**MITSUBISHI HEAVY INDUSTRIES, LTD.**  
16-5, KONAN 2-CHOME, MINATO-KU  
TOKYO, JAPAN

**Subject: Amended MHI's Response to US-APWR DCD RAI No.584-4468 Revision 0 (SRP 09.02.02)**

Amended Responses to Request for Additional Information  
No. 584-4468, Revision 0

**US-APWR Design Certification  
Mitsubishi Heavy Industries  
Docket No. 52-021**

Figure 9.2.7-1 Essential Chilled Water System Flow Diagram (Sheet 1 of 4)

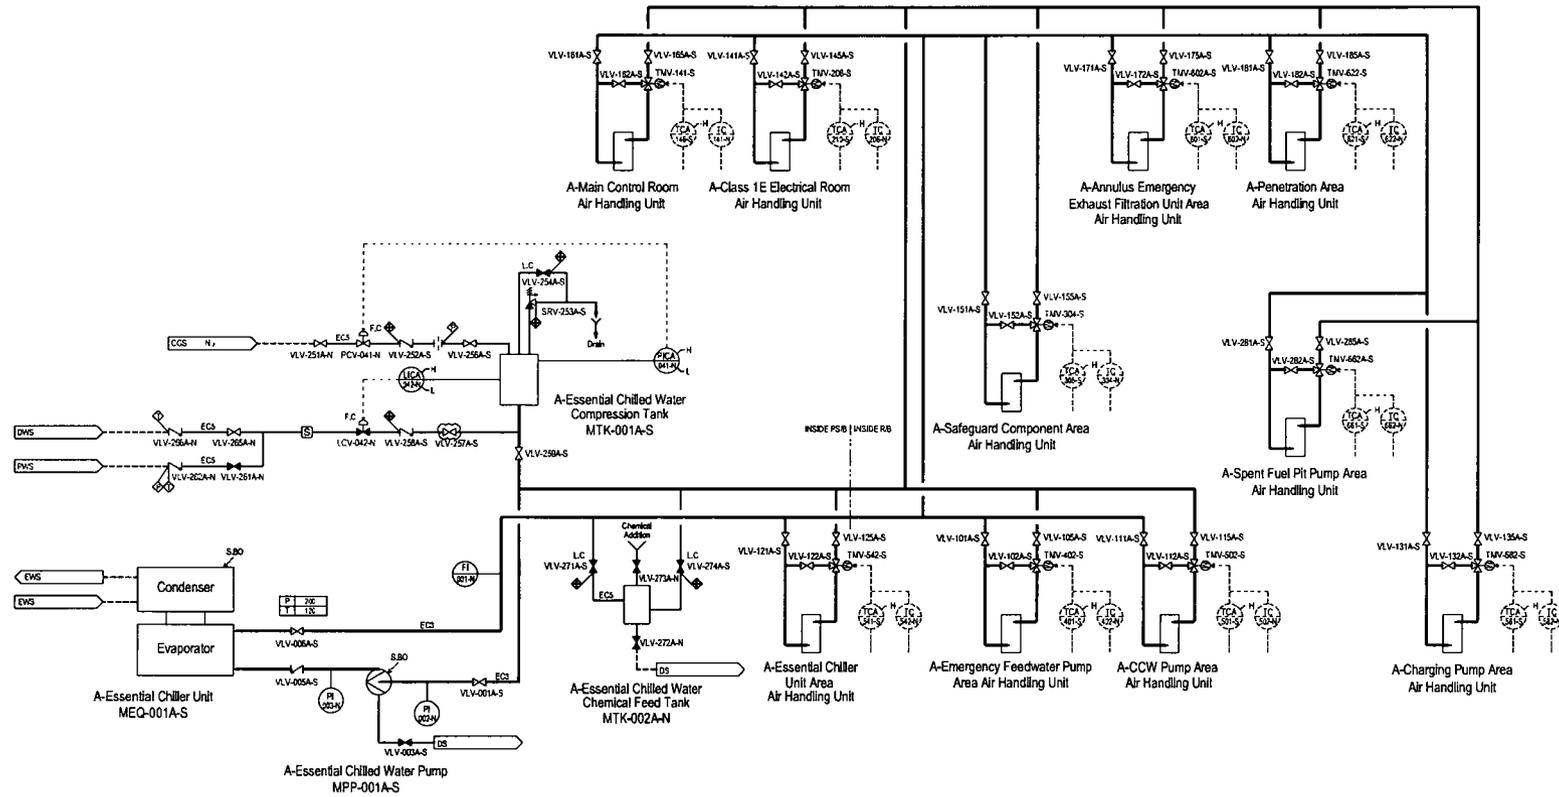
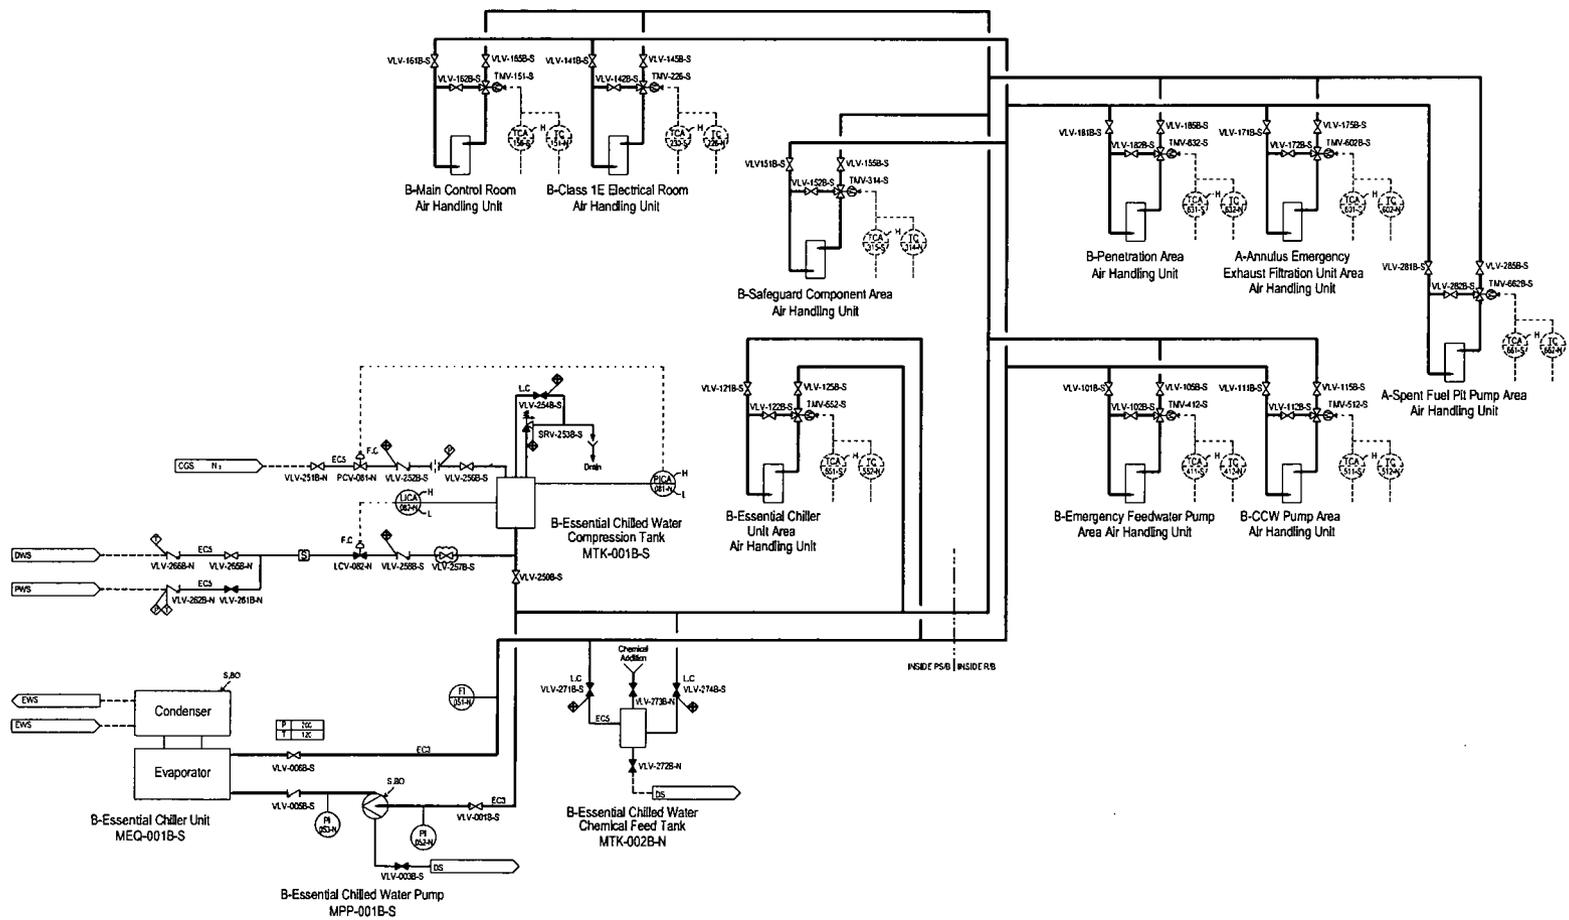
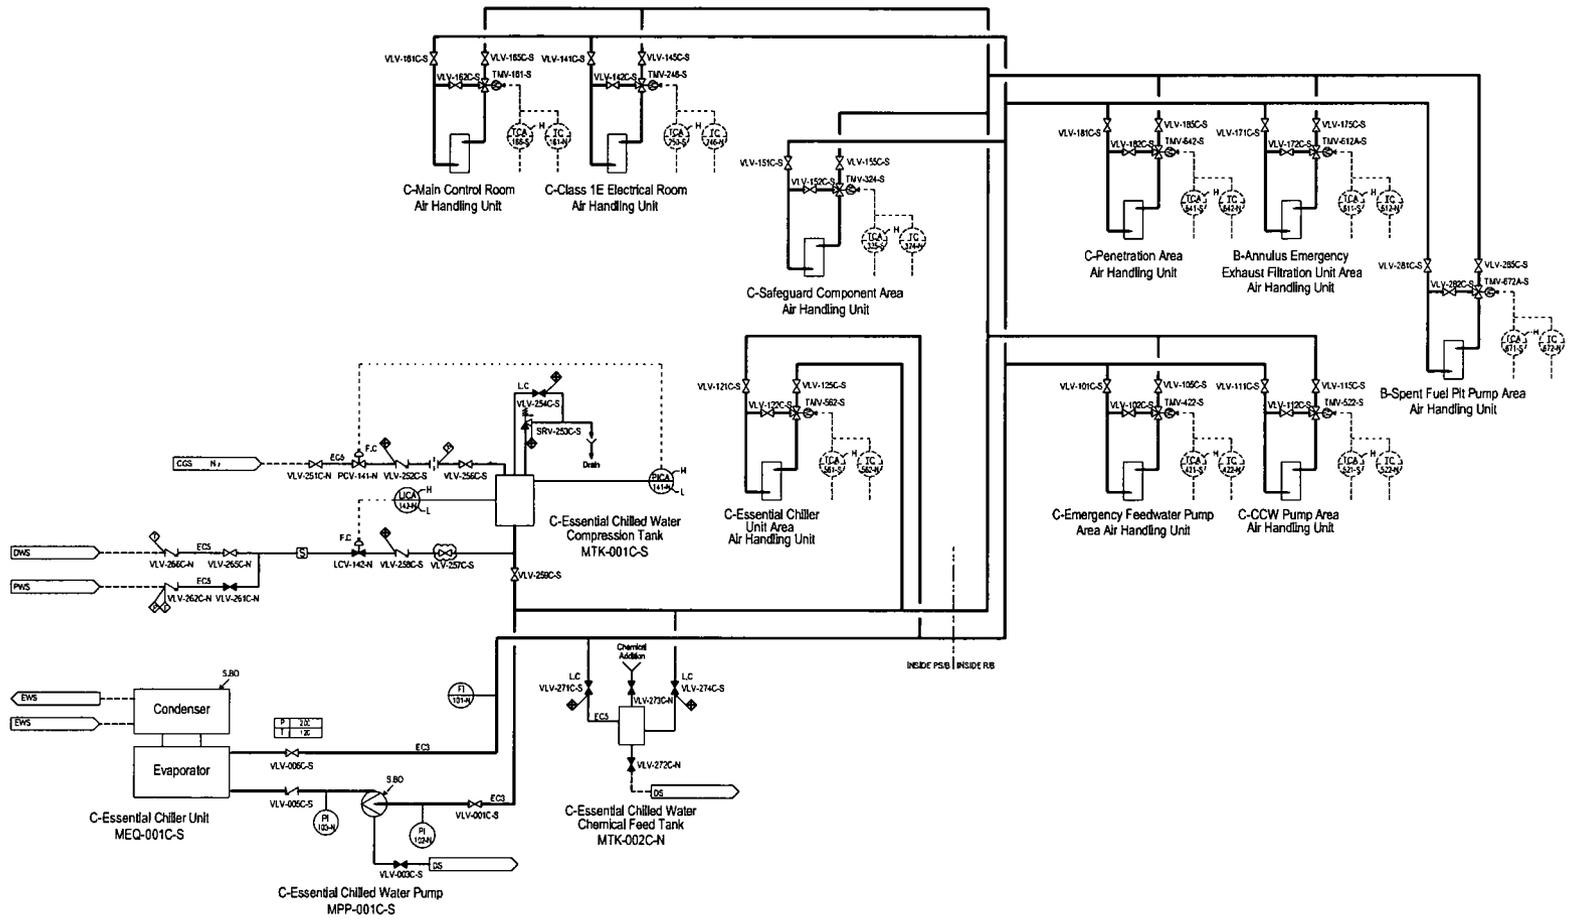
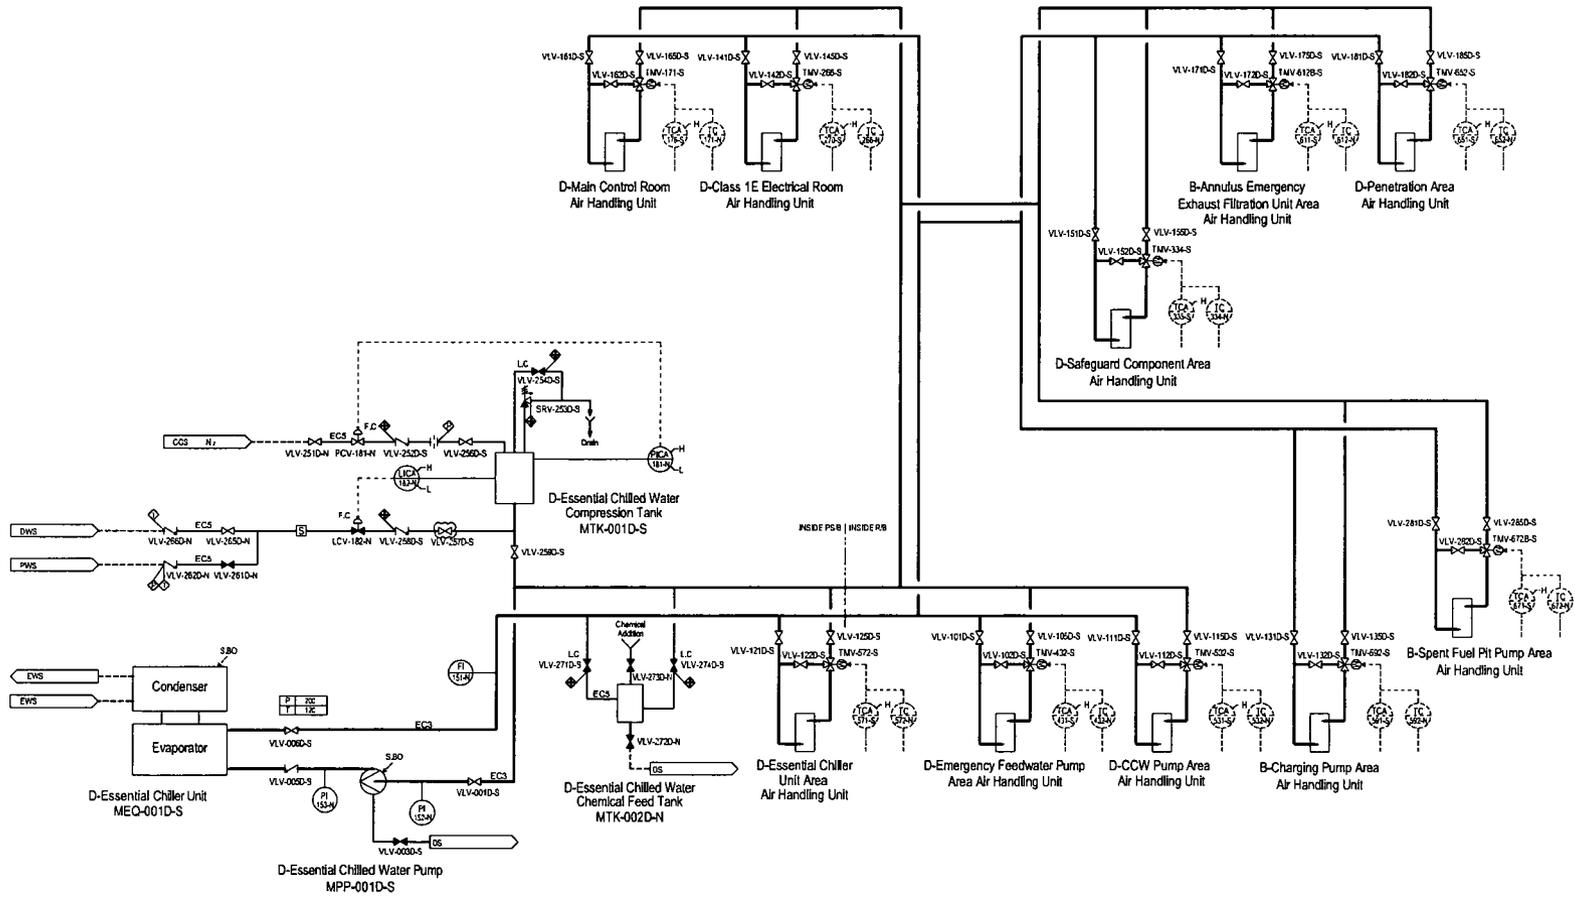
1. The staff asked the applicant to revise the DCD to address Tier 2, DCD Figure 9.2.7-1 not showing where indications are displayed (e.g., local, remote panel, control room), and what instruments provide input to a process computer and/or have alarm and automatic actuation functions. This item was not addressed anywhere in the applicant's RAI response. Therefore, the applicant is asked to address the original staff request to show on Figure 9.2.7-1 where indications are displayed and what instruments provide input to a process computer and/or have alarm and automatic actuation functions. Or, as indicated in RG 1.206 (C.I.9.2.1.5), describe the system alarms, instrumentation, and controls. Include a description of the adequacy of instrumentation to support required testing, as well as the adequacy of alarms to notify operators of degraded conditions.

For question 5 [from RAI 343-2208, Question 09.02.02-13 response], explain why all instrumentation described in Section 9.2.7.5 are not found on Figure 9.2.7-1 and 9.2.7-2. In addition, indicate whether expansion tank level alarm should be included in Section 9.2.7.5.

DCD, Revision 2, incorporated changes to Figure 9.2.7-1 to include additional details related to instrumentation and controls for the essential chilled water system (ECWS), such as compression tank level indication, control and alarm; air handling unit temperature control; and chiller and chilled water pump automatic start signals. The instrumentation and control level of detail shown on Figure 9.2.7-1 is consistent with other system P&IDs within DCD Chapter 9. Additional description of ECWS instrumentation and control is provided in DCD Section 9.2.7.5.1. The automatic start of standby ECWS chillers and pumps upon receipt of an ECCS actuation signal is described in DCD Section 9.2.7.2.1.

DC applicant will revise Figure 9.2.7-1 and 9.2.7-2 to indicate that the ECWS compression tank relief valve discharge is routed to a local floor drain. .

DC applicant will revise Tier 2, DCD Revision 3, Section 9.2.7.5.1 to include ECWS compression tank level indication and alarm in the list of MCR instrumentation and to provide additional description of the function of the MCR instrumentation. The compression tank level indication symbols in Figure 9.2.7-1 and 9.2.7-2 will be revised to be consistent with following change:

Figure 9.2.7-2 Non-Essential Chilled Water System Flow Diagram (1 of 3)

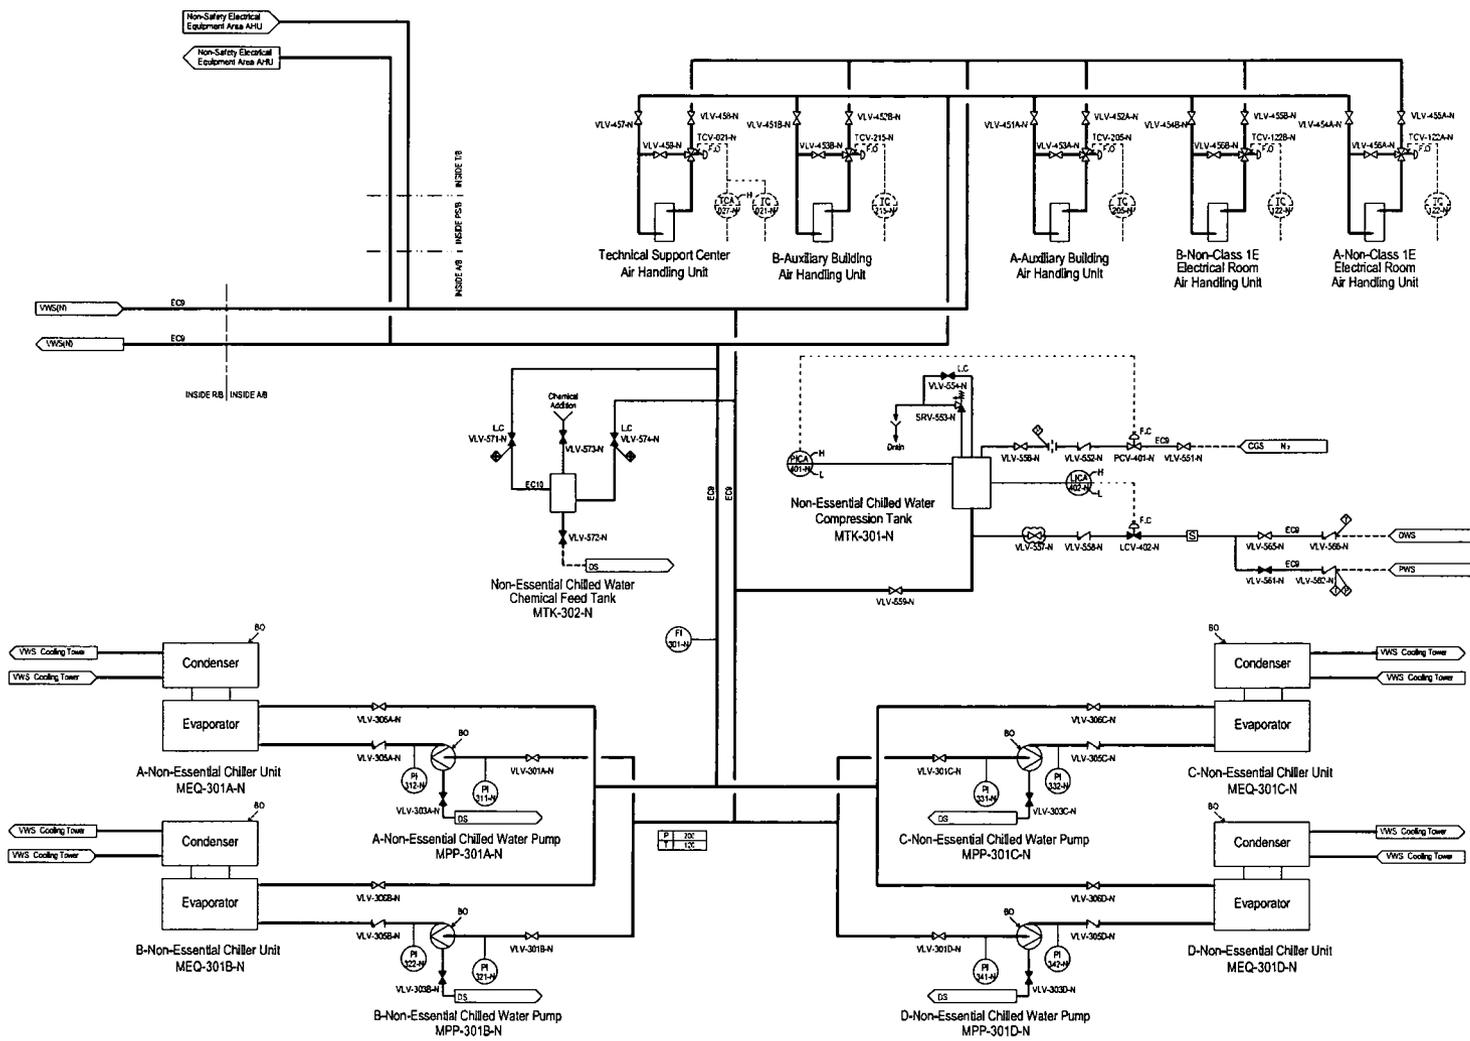
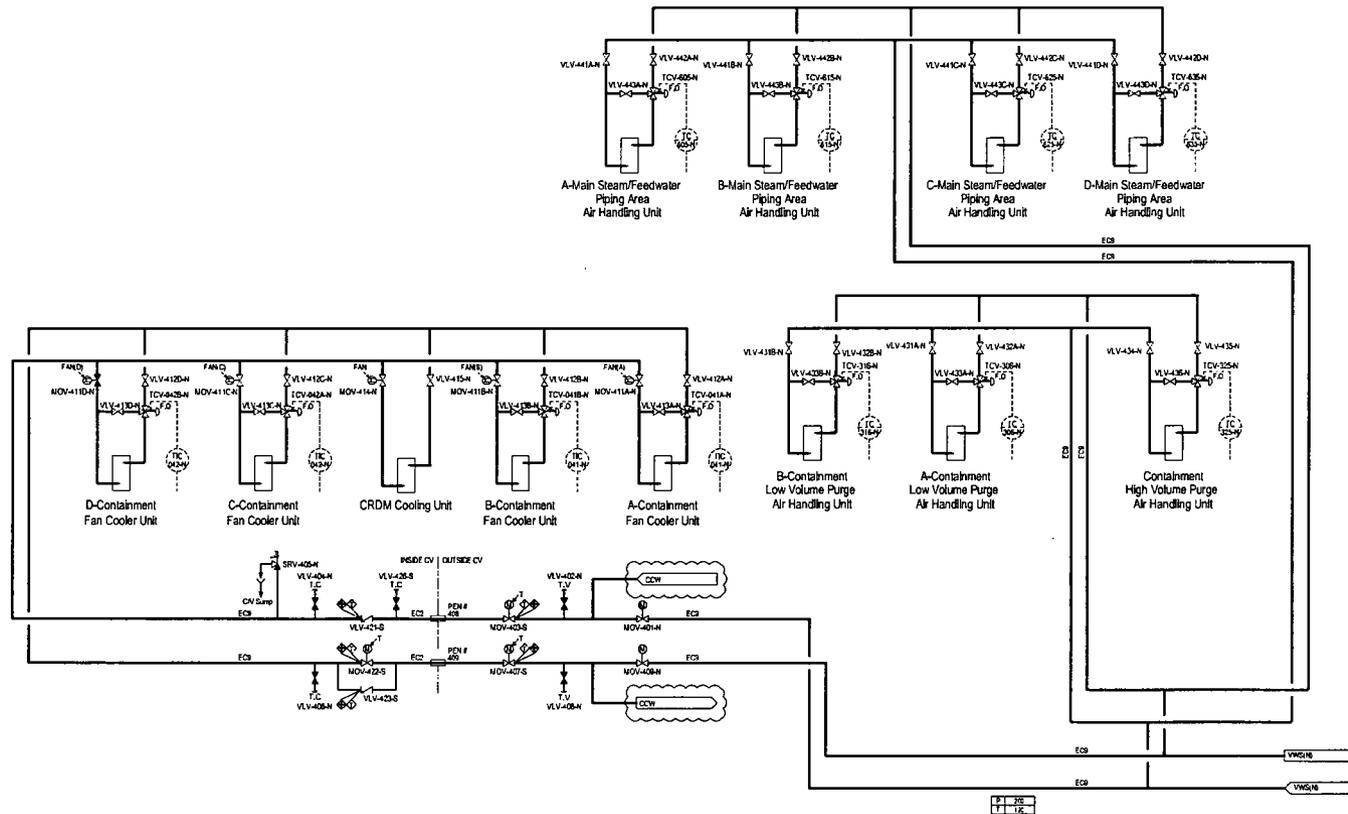
4. Tier 2 Table 3.2-2 (page 55 of 57) references "Valves VWS-MOV-425, -426" as Seismic Category I. However, Valve "-426" is not shown on non-ECWS Figure 9.2.7-2.

Tier 2 Table 3.2-2 (page 55 of 57) references "Valves VWS-MOV-425, -426" as Seismic Category I. However, Valve "-426" is not shown on non-ECWS Figure 9.2.7-2.

VWS-MOV-426 was erroneously listed in DCD Table 3.2-2. In addition, as described in the response to DCD RAI 697-5502, Question 09.02.02-80, the valve numbers VWS-MOV-424 and 425 shown in DCD Revision 3 will be changed to NCS-MOV-241 and 242. Therefore, Table 3.2-2 will be revised to remove the valves VWS-MOV-424 and 425. Figure 9.2.7-2 will be revised to incorporate these changes.

DCD Figure 9.2.7-2 will be revised to delete the CCW supply and return line isolation valves, VWS-MOV-424, 425, since the valves are changed to NCS-MOV-241 and 242 as described in the response to DCD RAI 697-5502, Question 09.02.02-80.

**Figure 2.7.3.6-1 Non-Essential Chilled Water System**

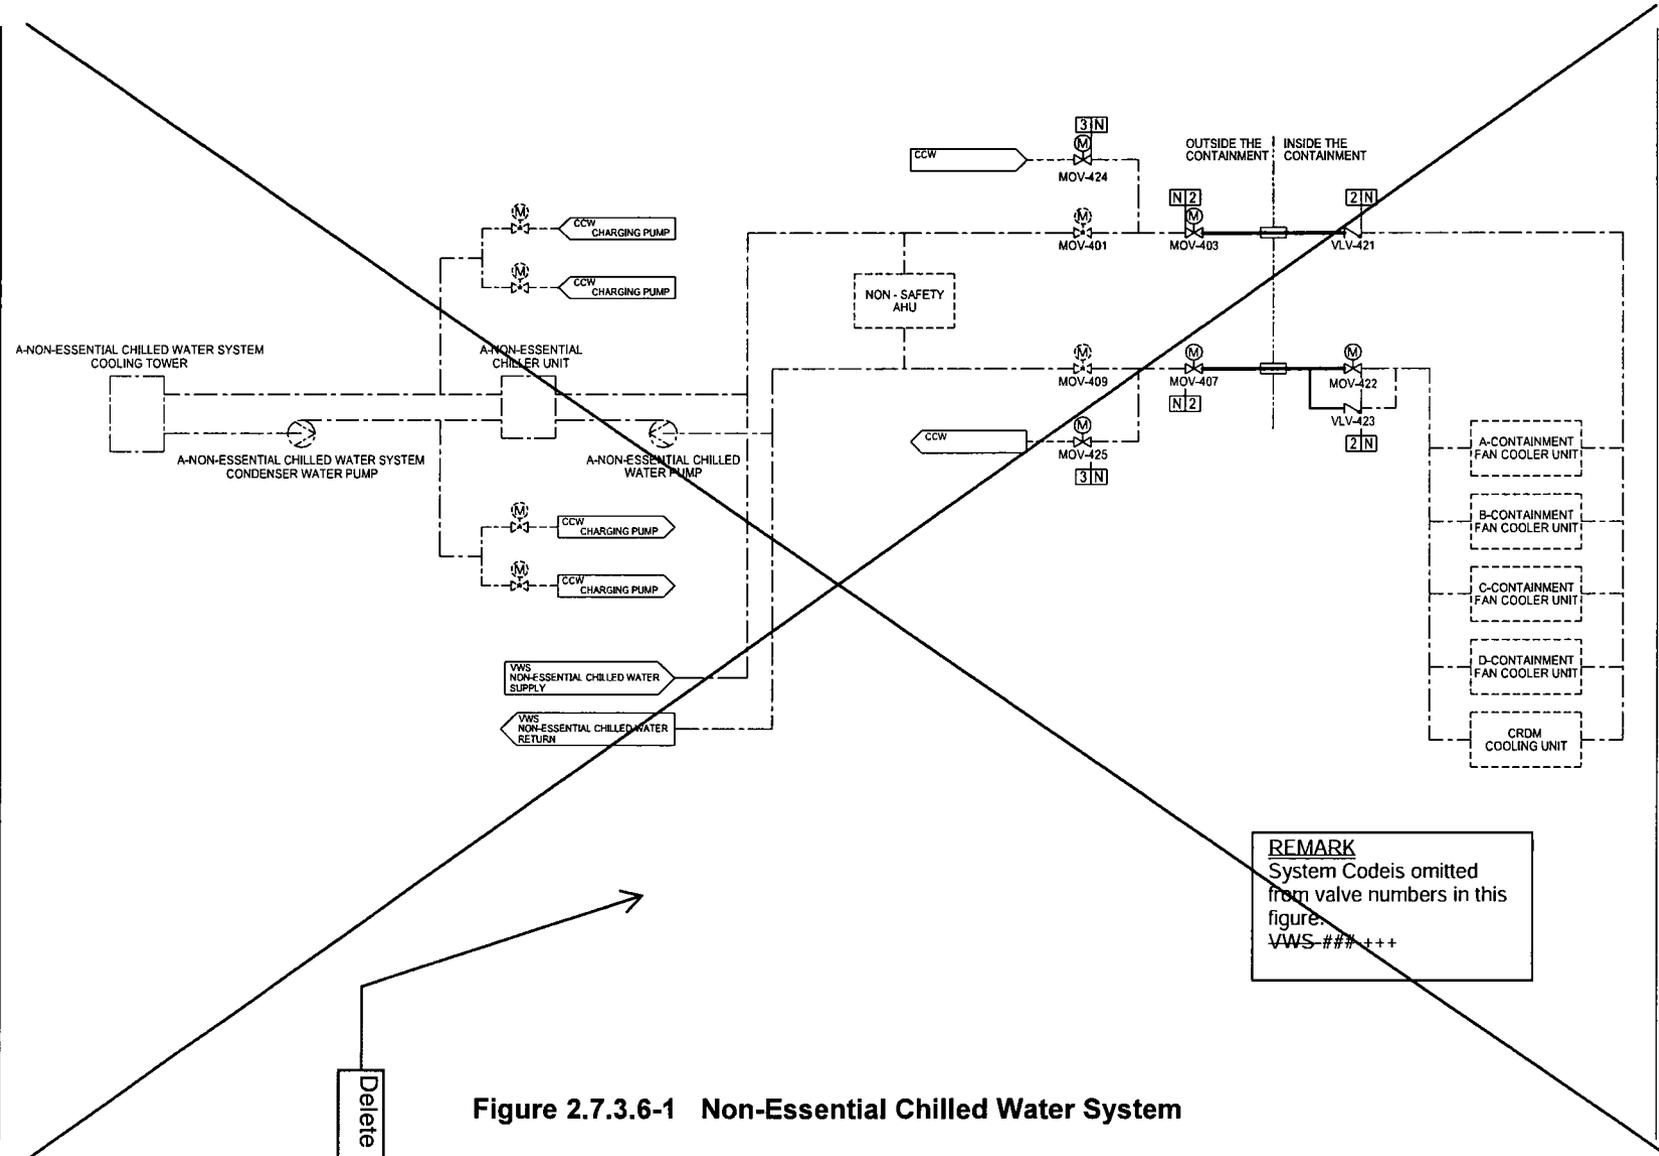
Although the Introduction Section in Chapter 1 of the Tier 1 DCD states that "information contained in the Tier 1 document was derived from the Tier 2 document," the staff found that much of the information provided in DCD Tier 1 is not described in Tier 2 DCD Section 9.2.7 (e.g., active safety function, loss of motive power position, harsh environment considerations, MCR alarm and display, control function, and RCS display). This information needs to be added to Tier 2. The applicant proposed to revise Tier 2 Section 9.2.7 to add the missing information that is included in Tier 1. However, the applicant did not provide a markup of the proposed Tier 2 DCD changes; therefore, the staff is unable to determine the acceptability of the proposed changes until the next DCD revision.

Therefore, Tier 1 DCD Section 2.7.3.6 will be revised to delete Tables 2.7.3.6-1, -2, and Figure 2.7.3.6-1 since they are no longer required to be included in the DCD.

Tier 1 DCD Section 2.7.3.6 will be revised to delete Tables 2.7.3.6-1, -2, and Figure 2.7.3.6-1. Tier 1 DCD Section 2.7.3.6.1 will be revised as follows:

Delete Figure 2.7.3.6-1
